SUBJECT: Forwards proposed rev to SSES emergency plan for review & approval. Proposed rev contains listed changes, including relocation of EOF to Northeast Div Headquarters, EOF activation & relocation of ERDS. *see Reports*

SUSQUEHANNA STEAM ELECTRIC STATION
PROPOSED REVISION TO THE EMERGENCY
PLAN: MOVING THE EOF TO THE NORTHEAST
DIVISION HEADQUARTERS
PLA-4298 FILE R41-2

Docket Nos. 50-387
and 50-388

LOCATIONS OF EMERGENCY RESPONSE FACILITIES

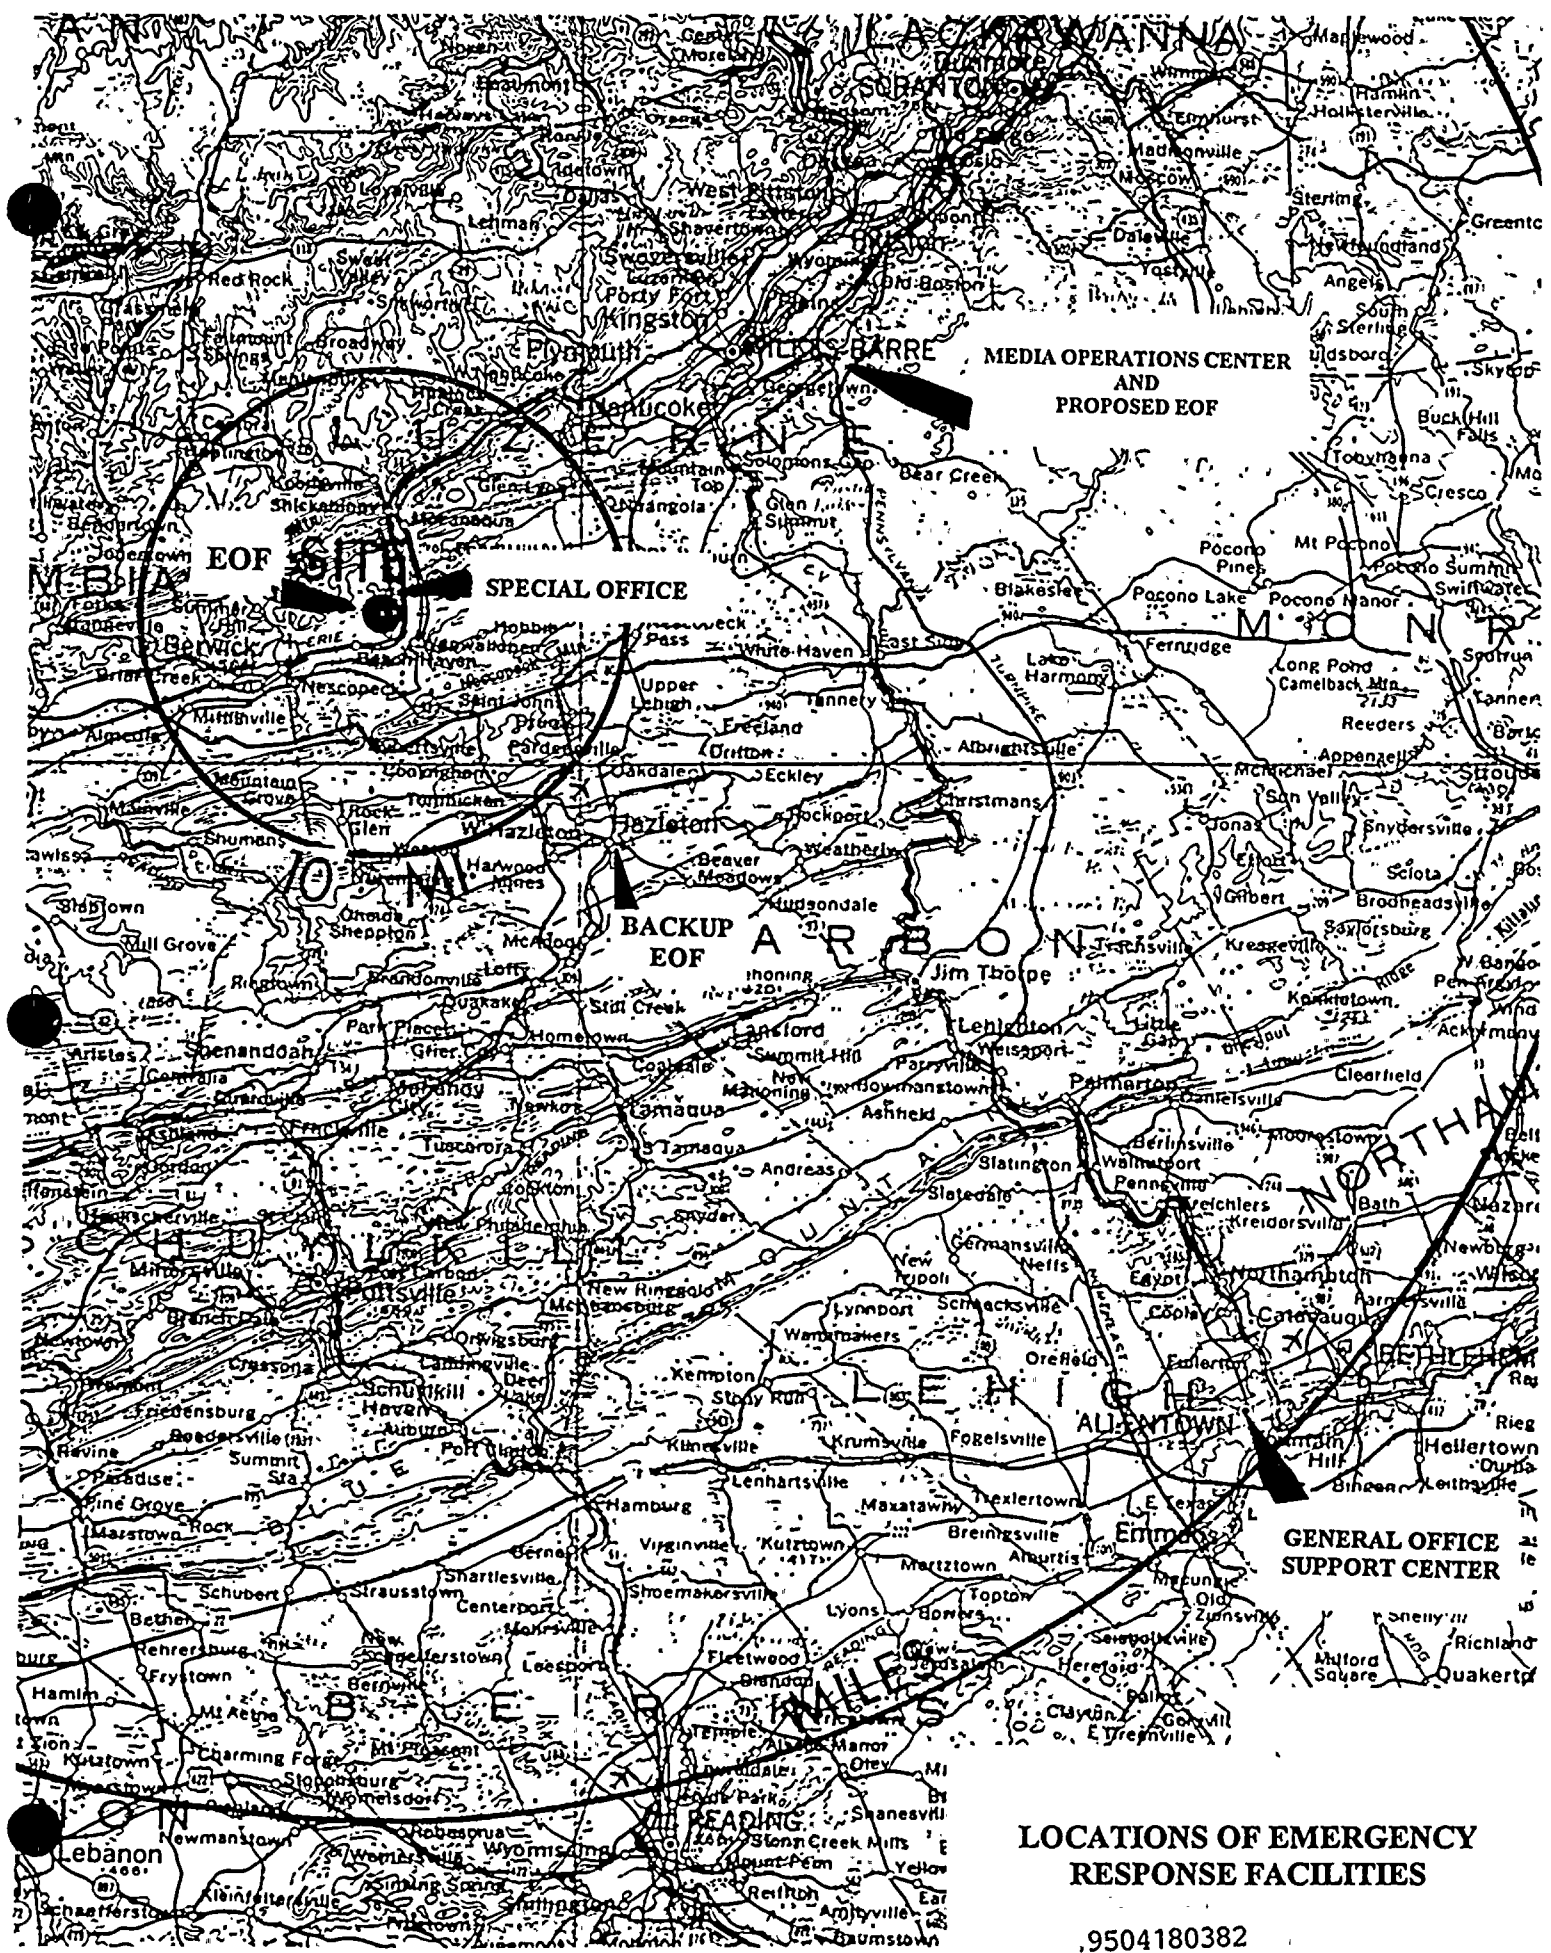
The proposed new location for the EOF is PP&L's Northeast Division Headquarters. The Northeast Division Headquarters is located in Plains Township approximately 3 miles east of Wilkes-Barre, PA just off PA Route 115. The proposed EOF is about 22 miles from the TSC and therefore, NRC approval is required prior to relocating the EOF. The proposed EOF is accessible by two major highways (Interstate I-81 and the PA Turnpike) and is approximately 15 minutes from the Scranton/Wilkes-Barre Airport. Except for the staffing time recommendation and SPDS availability, the new EOF will meet the guideline of NUREG 0696 Section 4. These exceptions are discussed later in this submittal.

Attachment 1 shows the relative locations of our existing and proposed emergency response facilities.
